TO: Freightliner Dealer Principals, General Managers, Sales Managers, Service Managers, Parts Managers	FROM: Anthony Washington, Senior Manager, Regulations and Certifications
Re: Launch Recall Campaign Notification Model Sprinter Model Years 2019-2021 Check Partition Wall Bolts	DATE: January, 2024

IMPORTANT RECALL CAMPAIGN INFORMATION

Campaign No. :	Campaign Desc. :	Check Partition Wall Bolts
2024010006	VS3TREWAN	
<p>This is to notify you of a Recall Campaign Launch to check the partition wall bolts on approximately 51 MY 2019-2021 Freightliner Sprinter Vans. The recall campaign will be visible on the www.safercar.gov website and may generate questions from customers. All affected VINs will be flagged as "OPEN" in VMI and cannot be sold.</p>		
Background		
Issue	Mercedes-Benz AG ("MBAG"), the manufacturer of Freightliner Sprinter Vans, has determined that on certain Sprinter (907 platform) vehicles, the bolted connection of the partition wall might not meet specifications. In this case, a deformation of the partition wall under load could be possible. In addition, an influence on the load securing function cannot be ruled out which could increase the risk of injury in the event

D68.74-A016-79

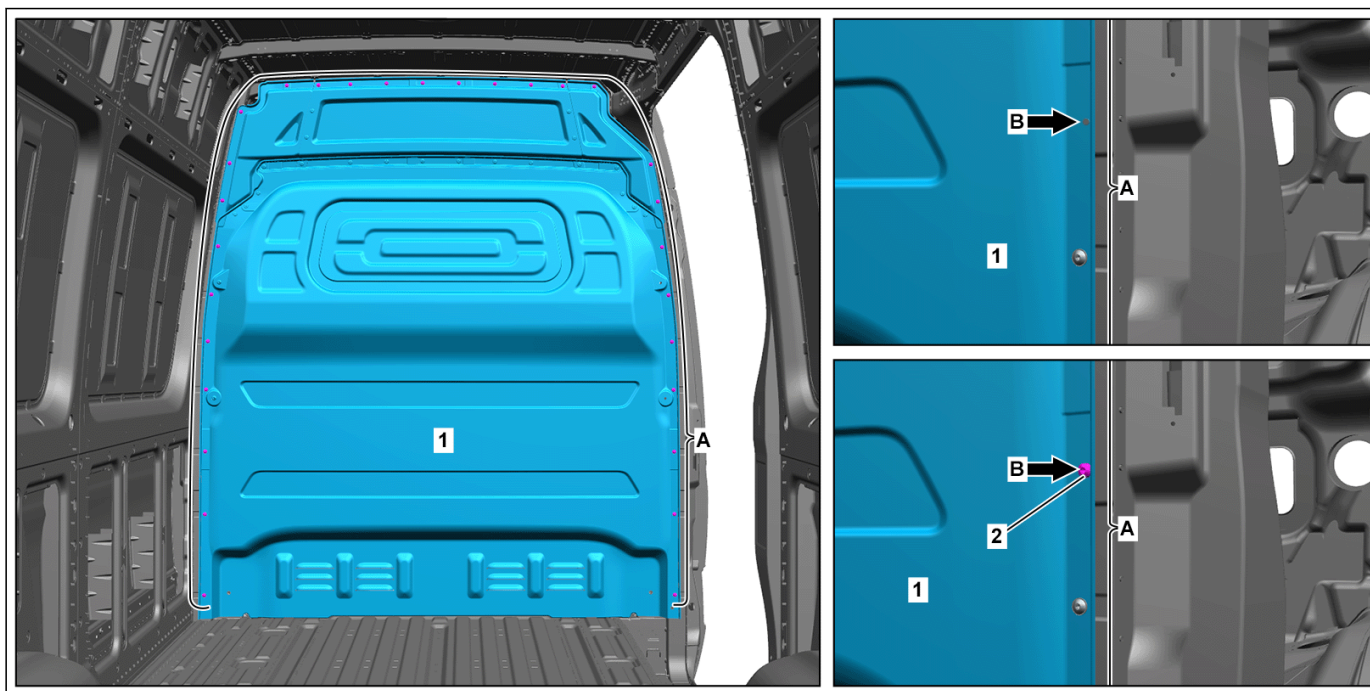
Additional screw connection		
2 	Remove B-pillar trims on driver and front passenger side and position outside working area.	 Do not unhook belts from seat belt retractors.	AR68.30-D-4705TS
3	Locate holes (arrow B) for additional screw connections at partition (1) and center punch.	 Holes must be drilled into the B-pillar for the additional screw connection. The holes (arrow B) in the partition (1) serve as a template.	
4	Drill holes for additional screw connection in B-pillar with \varnothing 4 mm bit.	 Commercially available devices/ tools Drill bit 4 mm	
5	Remove drill chips in B-pillars.	 Commercially available devices/ tools Wet and dry vacuum cleaner	
 Danger	Risk of explosion caused by paint vapors igniting. Risk of poisoning caused by inhaling paint vapors.	No smoking! No open fire! Use respiratory protection, protective clothing, gloves, safety glasses and protective skin cream. Ensure that the area is well ventilated.	AS98.00-Z-0002-01A

6 	Prime holes with a brush or spray can. Notes on paintwork repairs	 Use only primer fillers approved by manufacturer. See guidelines for paint technology in the workshop portal.	AH98.00-P-9408-02A
7	Screw in screws (2) and tighten.	 Tightening torque maximum 5 Nm.	
8 	Add cavity preservation in B-pillars with spray can.		AR97.20-D-1500TS
9 	Attach B-pillar trims on driver and front passenger side.		AR68.30-D-4705TS
